Architectural Review Board Staff Report

Project type: Amended Architectural Elevations

Location: Spirit Trade Center, Lot 12A

Description: **Spirit Trade Center, Lot 12A (Pets and Company):** Amended Architectural Elevations and Amended Architect's Statement of Design for a 2.01 acre "LI" Light Industrial District – zoned property located a half mile southwest of the intersection of Chesterfield Airport Road and Trade Center Boulevard.

Proposed Amended Architectural Elevations

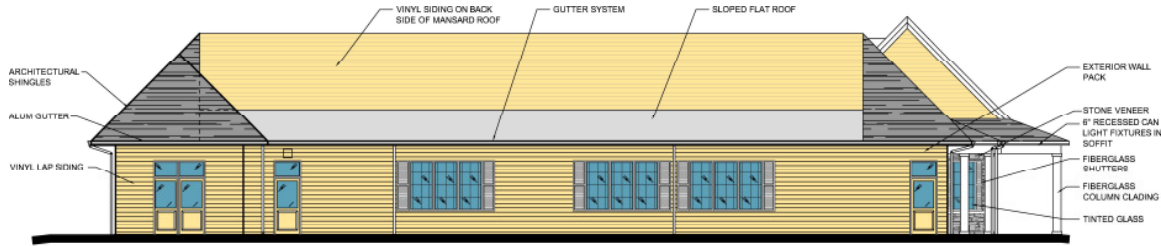
The overall design of the building differs from the surrounding properties. The form has not changed since the November 10, 2011 meeting of the Architectural Review Board in which this project was first presented. The only changes that are proposed at this time are to the materials and color palette. In lieu of using E.I.F.S as siding as presented on November 10, 2011, vinyl siding is now being proposed. The stone veneer base is utilized less on the north and south elevations while it has been removed on the west elevation.

Staff has reviewed the Amended Architectural Elevations and has found the application to be in conformance with the City of Chesterfield Zoning Ordinance 1003.152, and other applicable Zoning Ordinance requirements. Staff requests action on the Amended Architectural Elevation for Spirit Trade center, Lot 12A (Pet's and Company).
